MWO 9-2320-273-20-1

M O D I F I C A T I O N W O R K O R D E R

TRUCK TRACTOR, LINE HAUL,
50,000 GVWR, 6 X 4, M915 (NSN 2320-01428-4395)

1. **PURPOSE.** This modification consists of procedures to add a new air tank to the compressed air system.

FIGURE 1

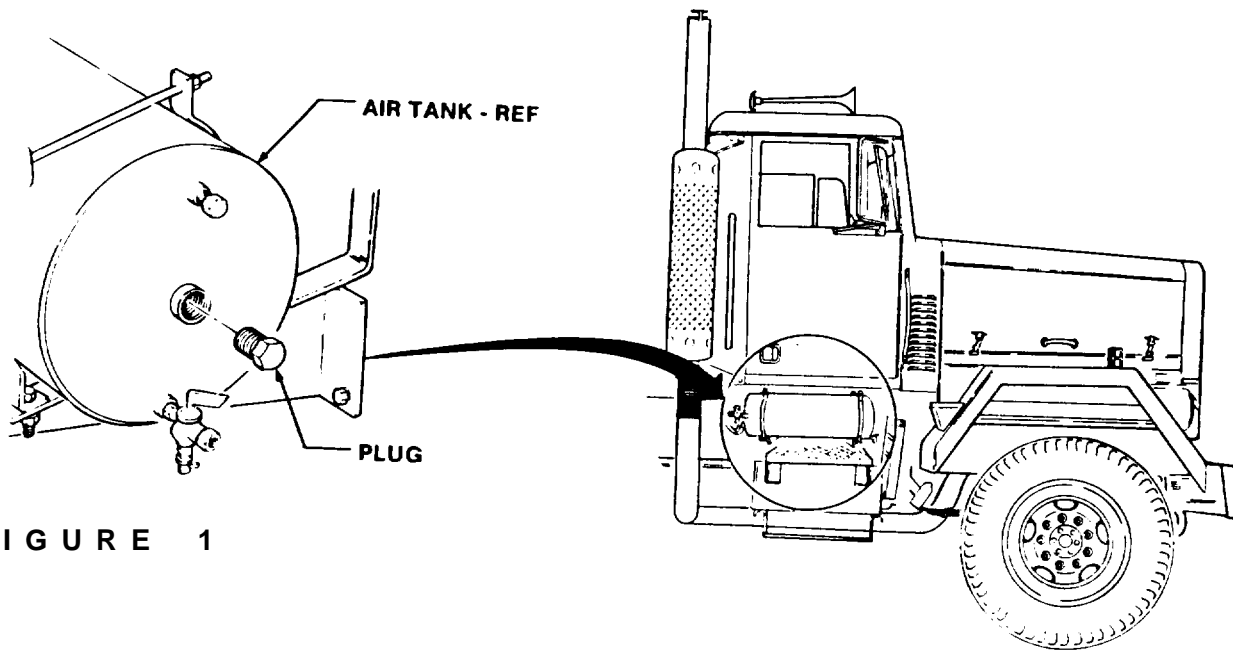
(2) Remove plug from front of air tank as shown in figure 1.

FIGURE 2

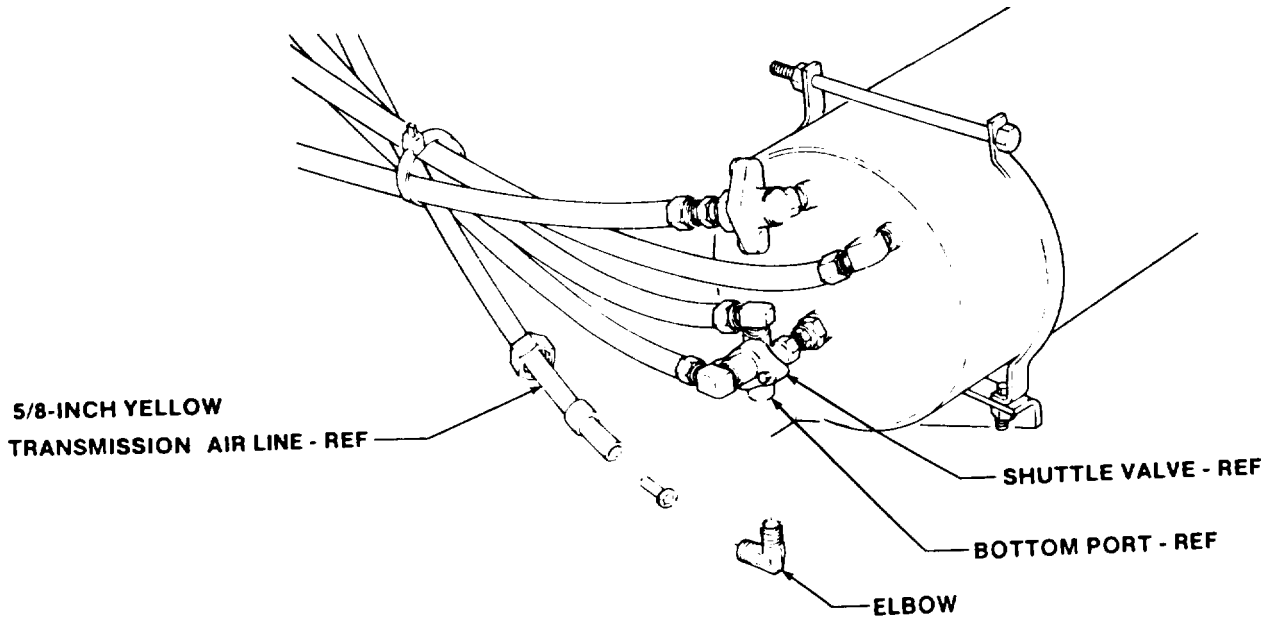
(3) Remove 5/8-inch yellow transmission air line from elbow on shuttle valve as shown in figure 2.

(4) Remove elbow from bottom port on shuttle valve as shown in figure 2.

FIGURE 3

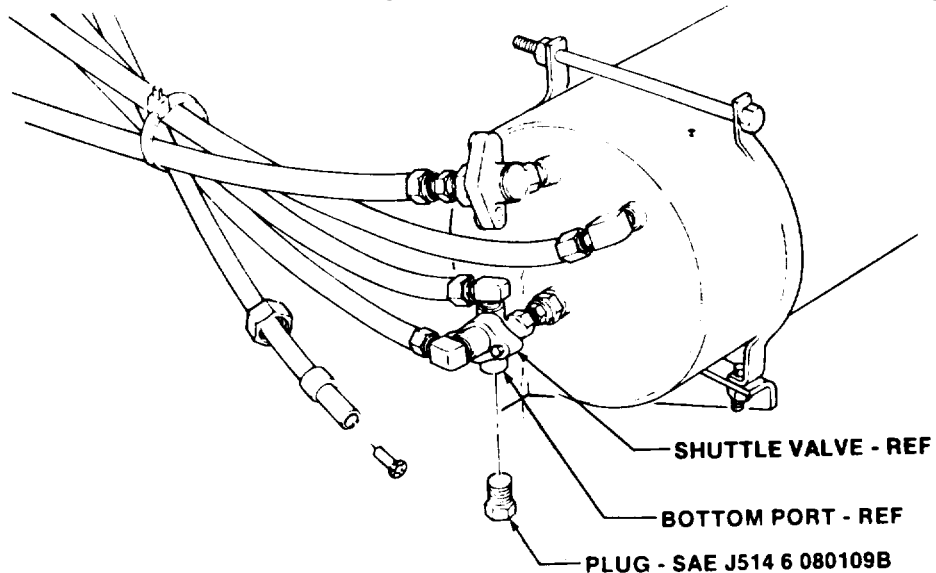
(5) Install SAE J514 6 080109B plug in bottom port of shuttle valve as shown in figure 3.

FIGURE 4

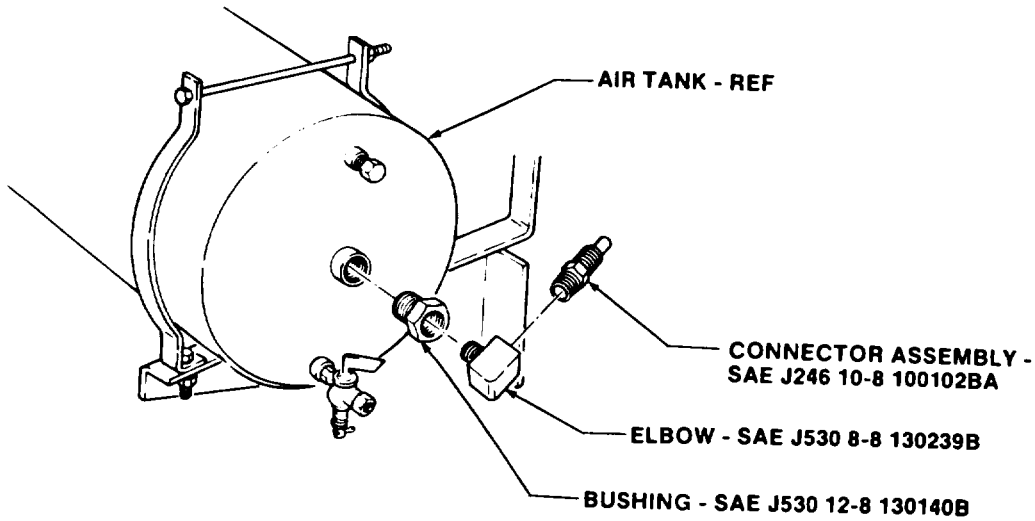
(6) Install SAE J530 12-8 130140B bushing in air tank as shown in figure 4.

(7) Install SAE J530 8-8 130239B elbow in bushing on air tank as shown in figure 4.

(8) Install SAE J246 10-8 100102BA connector assembly to elbow as shown in figure 4. Retain sleeve and nut for use in 10. b. (8).

FIGURE 5

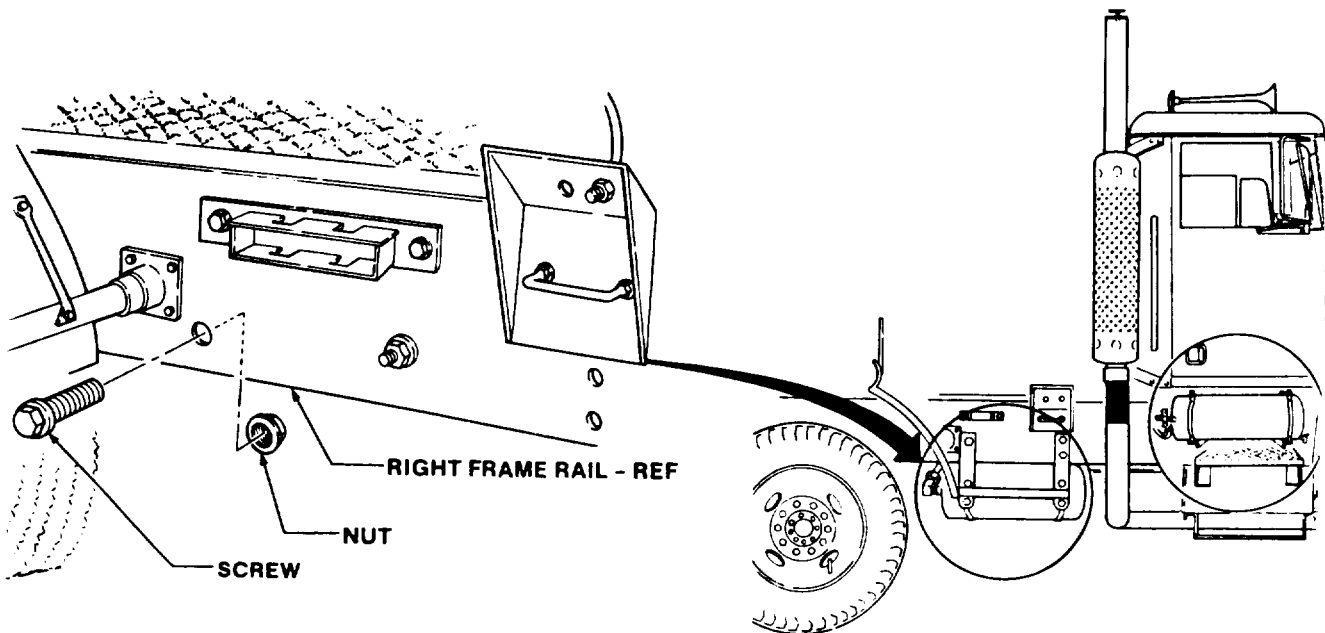
(9) Remove screw and nut from right frame rail as shown in figure 5.

FIGURE 6

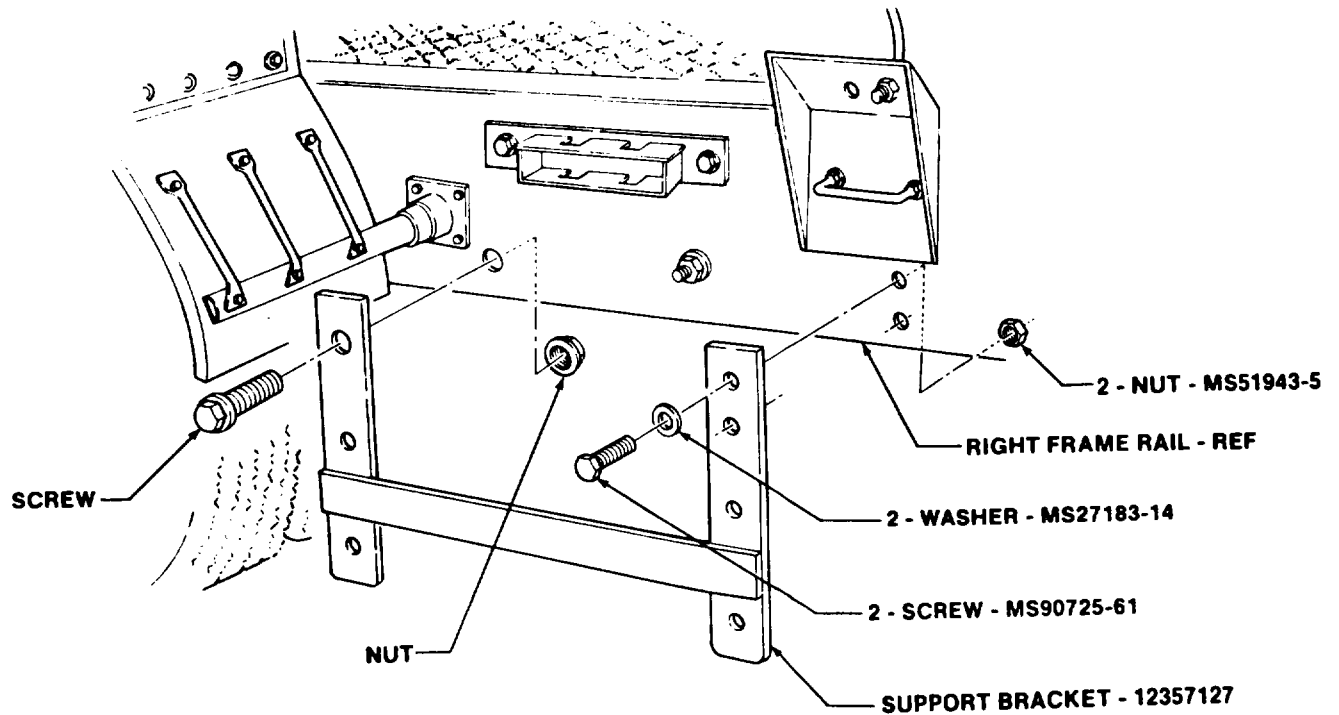
(10) Install 12357127 support bracket to right frame rail and secure with two MS90725-61 screws, MS27183-14 washers, and MS51943-5 nuts as shown in figure 6. Tighten nuts finger tight.

(11) Install screw (removed in step 9) through support bracket and right frame rail and secure with nut (removed in step 9) as shown in figure 6. Tighten nut finger tight.

(12) Tighten two screws installed in step (10) to 20 lb ft (40.7 N.m).

(13) Tighten screw installed in step (11) to 95 lb ft (128.8 N.m).

Figure 7

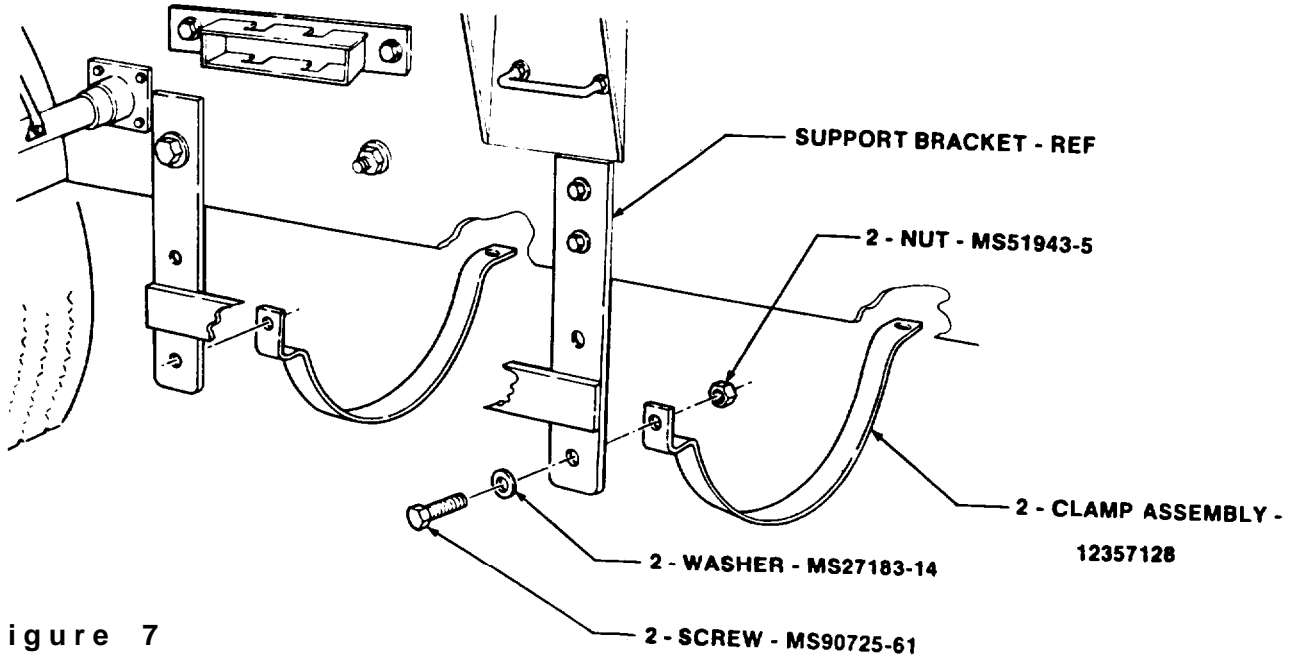
(14) Install lower half of two 12357128 clamp assemblies support bracket and secure with two MS90725-61 screws, MS27183-14 washers, and MS51943-5 nuts as shown in figure 7. Tighten screws 30 lb ft (40.7 N.m).

FIGURE 8

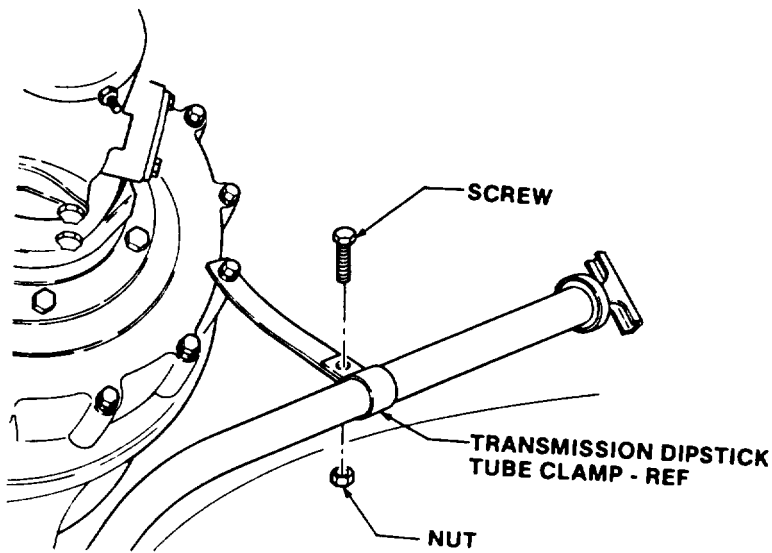
(15) Remove screw and nut from transmission dipstick tube clamp as shown in figure 8.

FIGURE 9

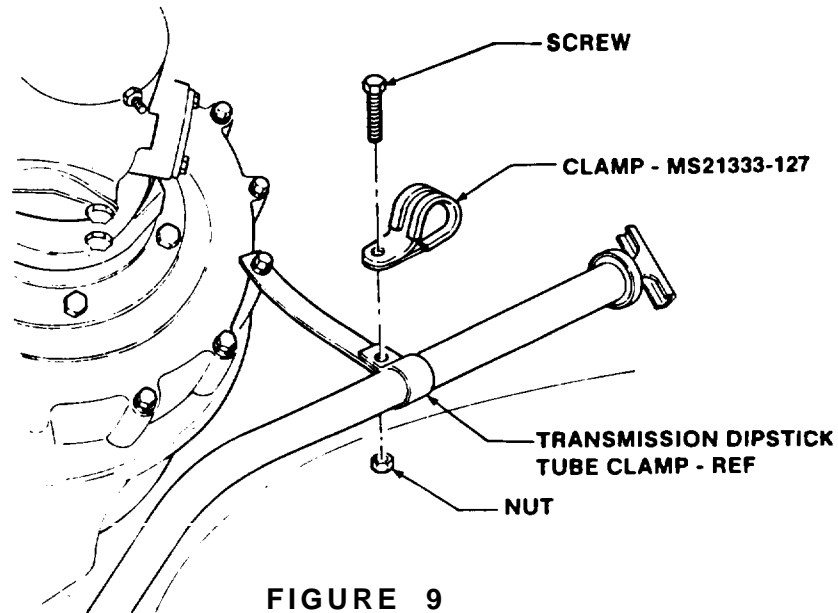
(16) Install MS21333-127 clamp on transmission dipstick tube clamp and secure with nut and screw (removed in step (15)) as shown in figure 9.

FIGURE 10

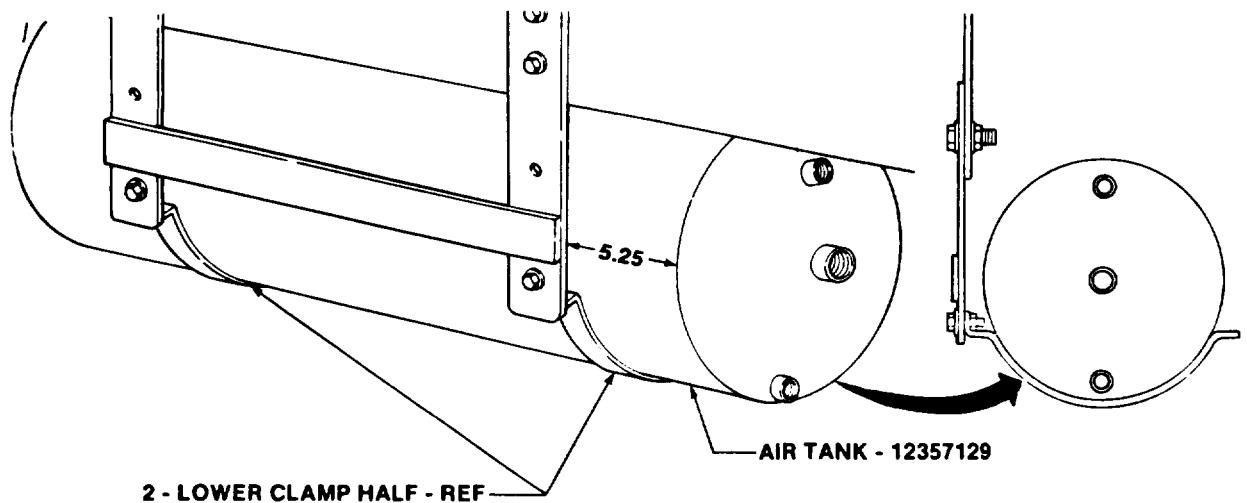
When installing air tank on clamp, ensure air tank is positioned as shown in figure 10.

(1) Position 12357129 air tank in lower half of two clamp assemblies as shown in figure 10.

FIGURE 11

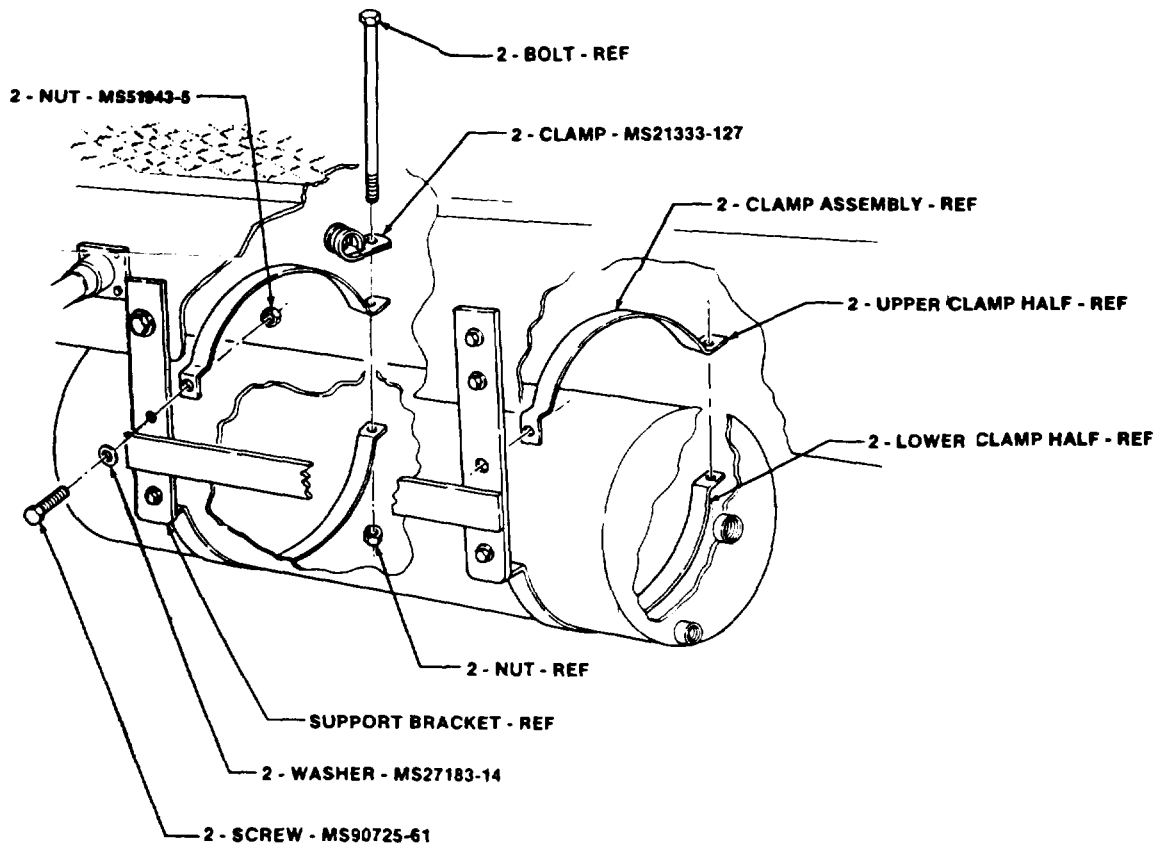
(2) Install upper half of two clamp assemblies to support bracket and secure with two MS90725-61 screws, MS27183-14 washers, and MS51943-5 nuts as shown in figure 11.

(3) Install two MS21333-127 clamps on two bolts and install bolts through upper and lower clamp halves and secure with two nuts as shown in figure 11. Tighten nuts finger tight.

(4) Secure four screws and nuts installed in steps 2 and 3.

FIGURE 12

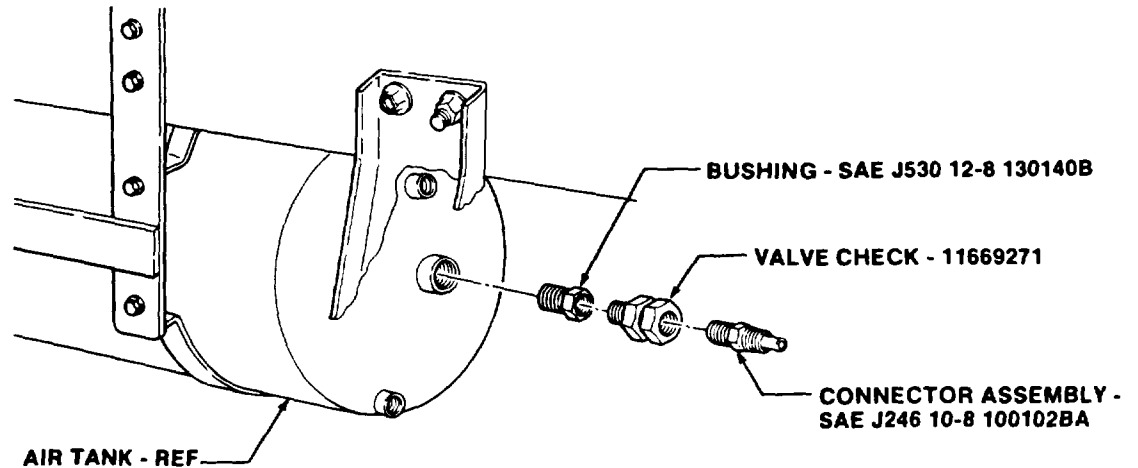
(5) Install SAE J530 12-8130140B bushing in forward end of air tank as shown in figure 12.

(6) Install 11669271 check valve in bushing on air tank as shown in figure 12.

(7) Install SAE J24610-8 100102BA connector assembly in check valve on air tank as shown in figure 12. Retain sleeve and nut for use in step 9.

FIGURE 13

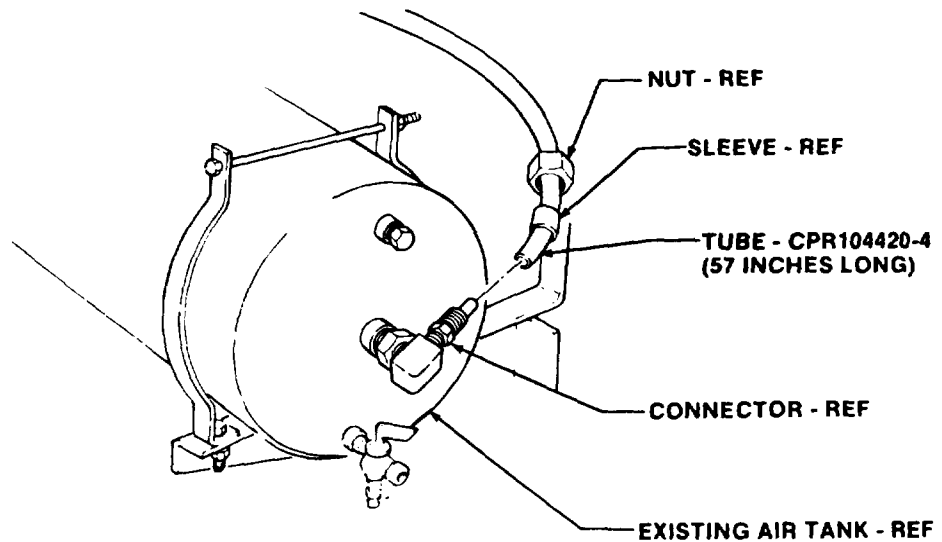
(8) Install CPR104420-4 (57 inches long) tube to connector on front of existing air tank and secure with sleeve and nut as shown in figure 13. Sleeve and nut retained from 10. a. (8).

Figure 14

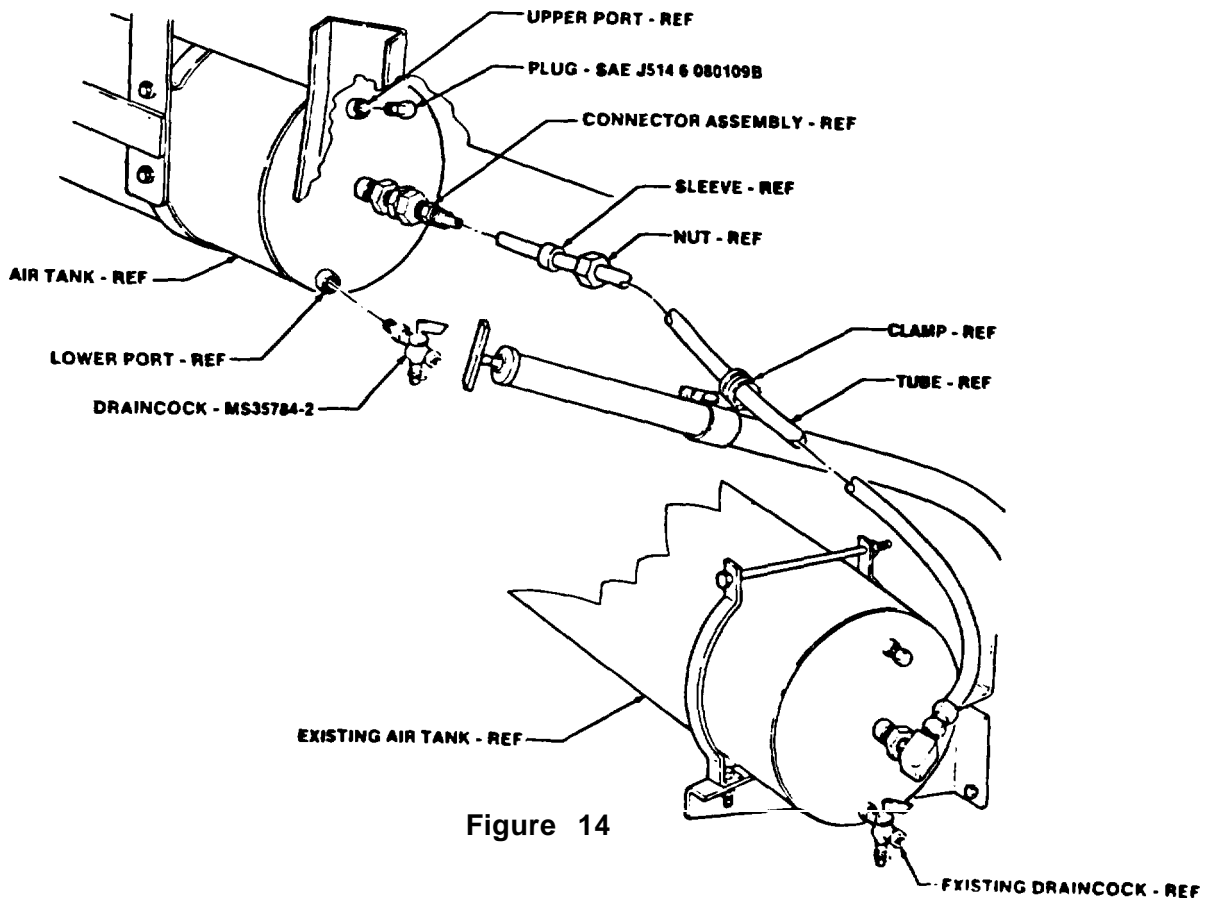
(9) Route tube through clamp to connector assembly on front of new air tank, cut tube, and secure tube to connector assembly with sleeve and nut as shown in figure 14.

(10) Install SAE J514 6 080109B plug in upper port on air tank as shown in figure 14.

(11) Install MS35784-2 draincock in lower port on air tank as shown in figure 14.
